## Staff Report

**To:** Development Review Board  
**From:** Michael Giguere, City Planner  
**Meeting Date:** March 26<sup>th</sup>, 2026  
**Subject:** Sketch plan review for a seven-lot subdivision for future residential development at 11 Meadow Terrace in the R1 District by Center for Technology Essex, owners.  
**File:** SP# 1.2026

Project:  
**MEADOW TERRACE  
 SUBDIVISION**  
 CENTER FOR  
 TECHNOLOGY ESSEX  
 Taft Street & Meadow Terrace  
 Essex Junction, Vermont

Figure 1: The small unlabeled parcel is shown with a green border. It is located behind the rear yards at 26 and 28 Taft Street.

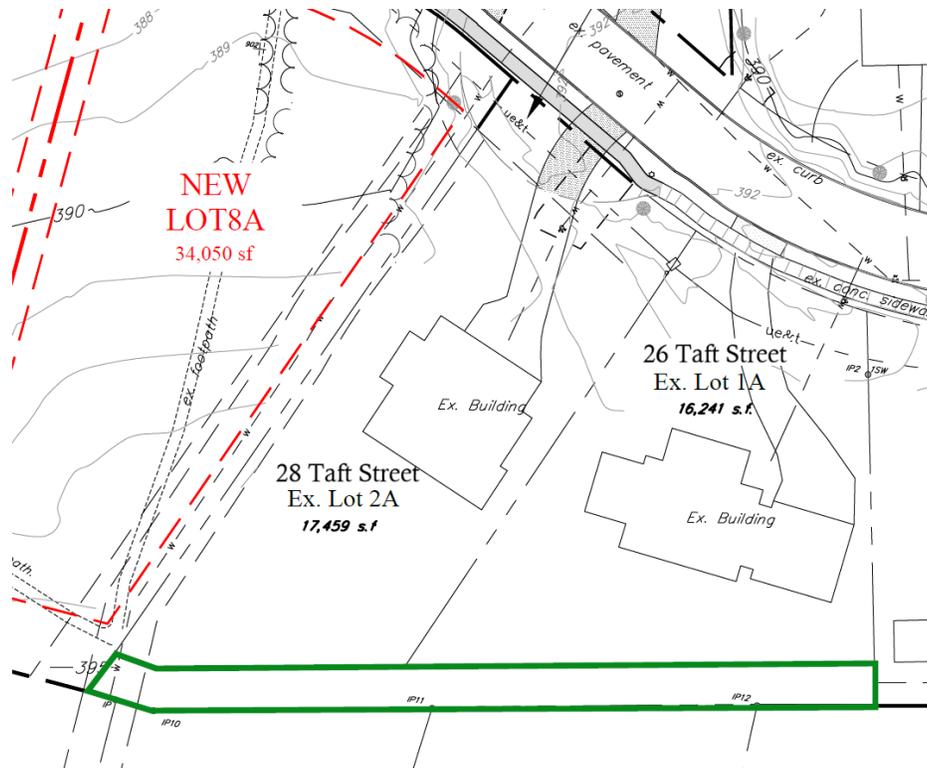
Staff have noted that there is a small, unlabeled parcel currently attached to Existing Lot 8A southeast of Existing Lots 1A and 2A that will not have any street frontage should this subdivision plan be approved. Staff have added a recommended condition of approval requiring the applicant to address this parcel through a boundary line adjustment or other means prior to Final Plat Approval.

- All staff comments shall be addressed to the satisfaction of City staff.
- All new utilities shall be installed underground per the LDC requirements in section 913.
- The unlabeled parcel southeast of Existing Lots 1A and 2A shall be addressed by the applicant prior to Final Plat Approval.

Figure 2: The sewer connection, highlighted in green, does not align with Lot 9A's buildable area as proposed.

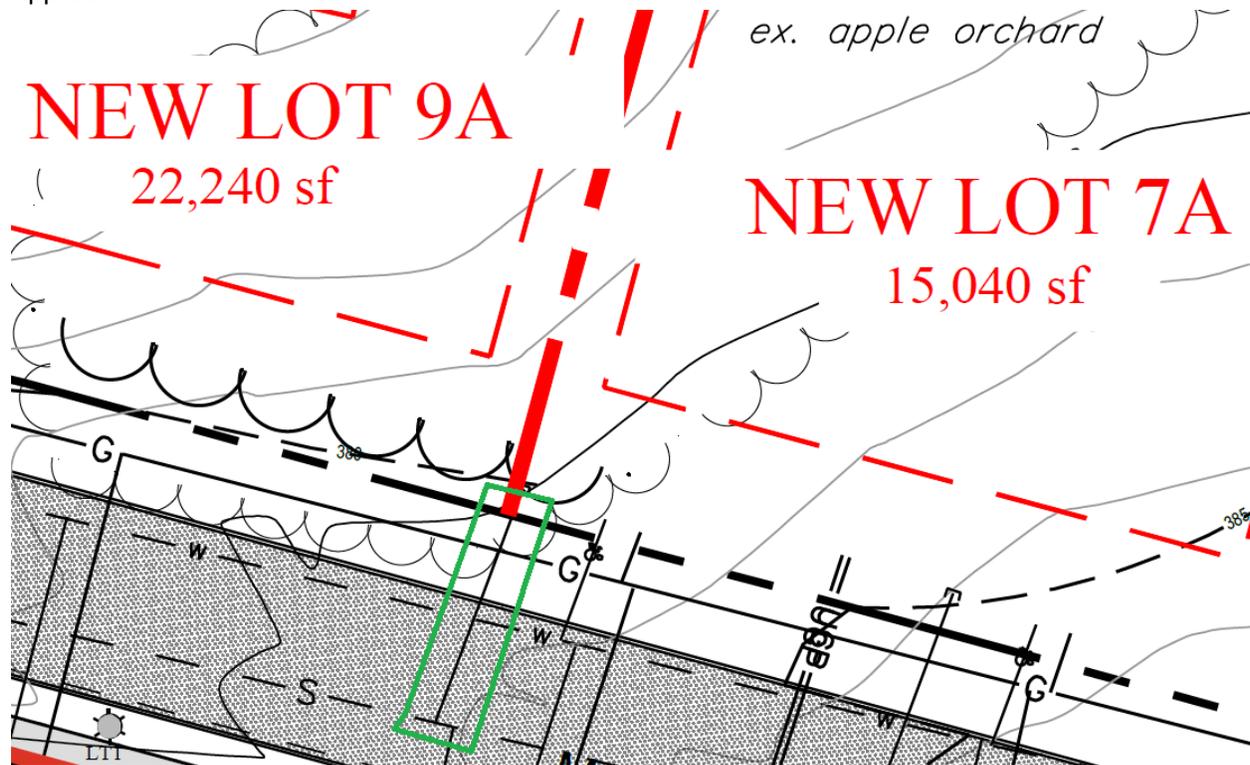
Staff have noted that some of the proposed connections to municipal water and sewer systems are not aligned with the areas designated for future home building, such as the sewer connection drawn on the border of lots 7A and 9A. The applicant should address these utility connection topics prior to Final Plat Approval.

Drawing Title  
**SKETCH PLAN MEADOW TERRACE**

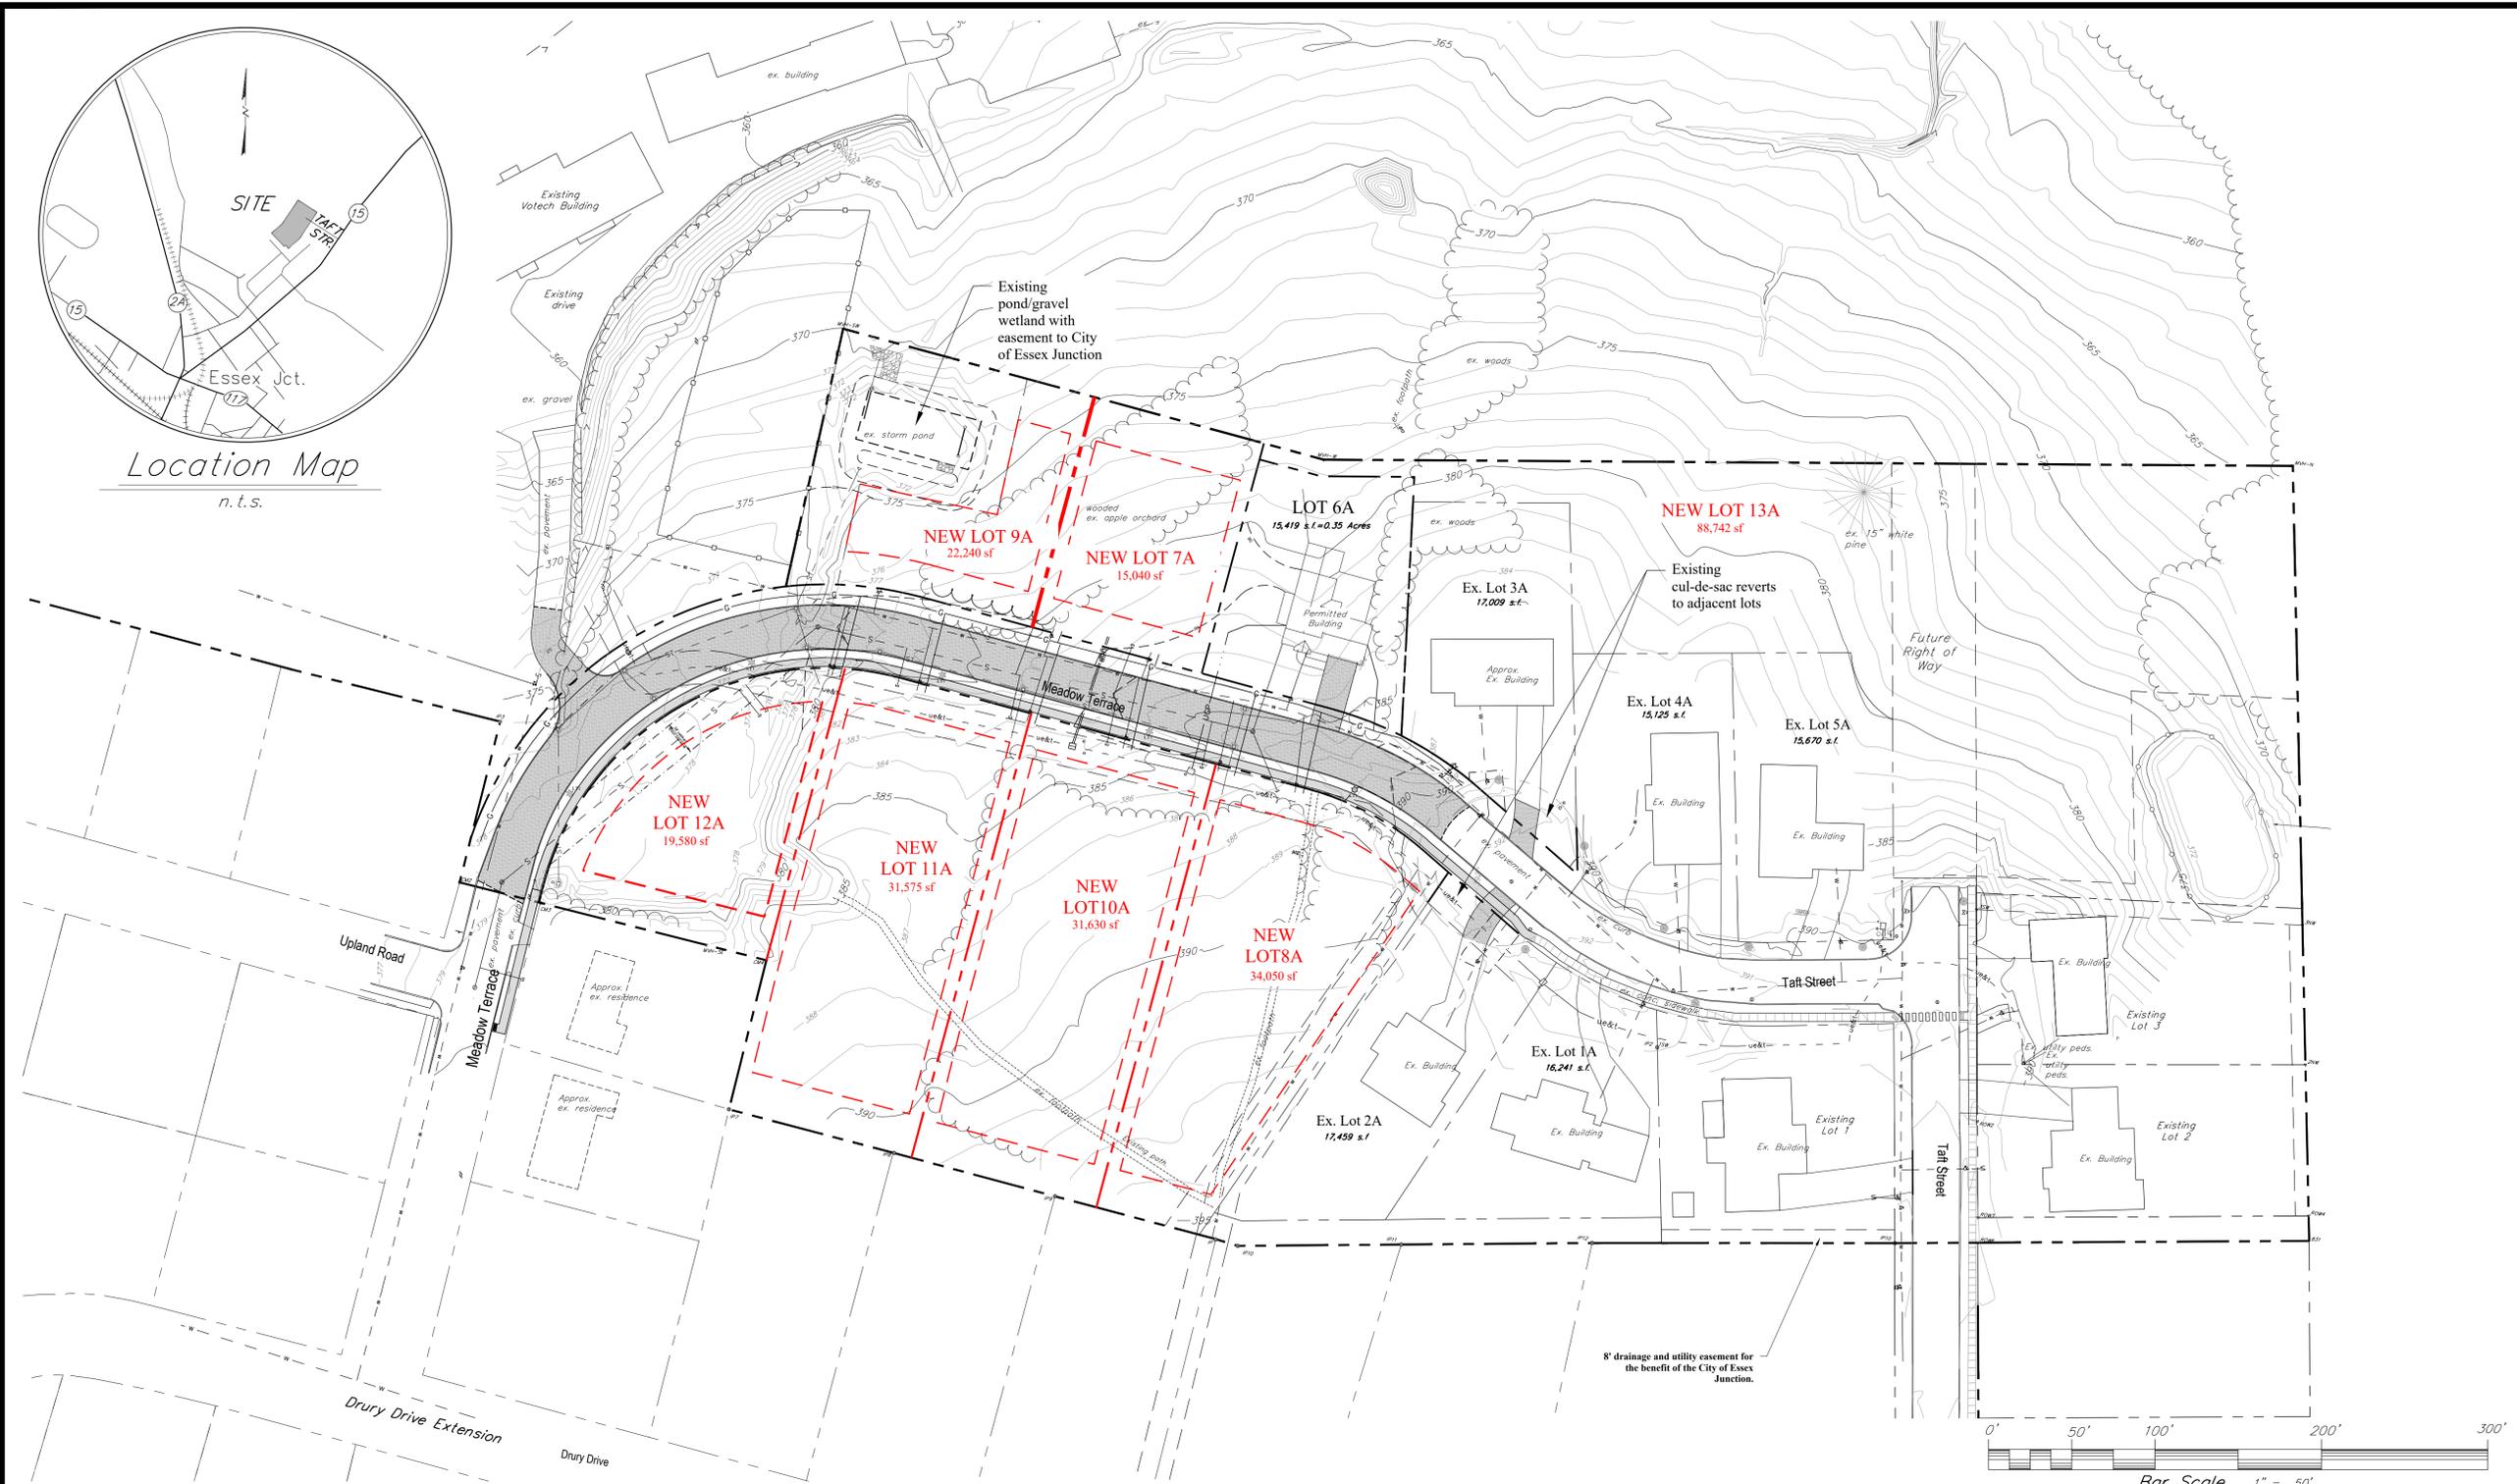
Staff have noted that the proposed buildable area outlined on Lot 9A overlaps with the stormwater pond. Additionally, it is currently unclear how stormwater will travel from Lot 7A to the gravel wetland. The applicant should address these stormwater management topics prior to Final Plat Approval.
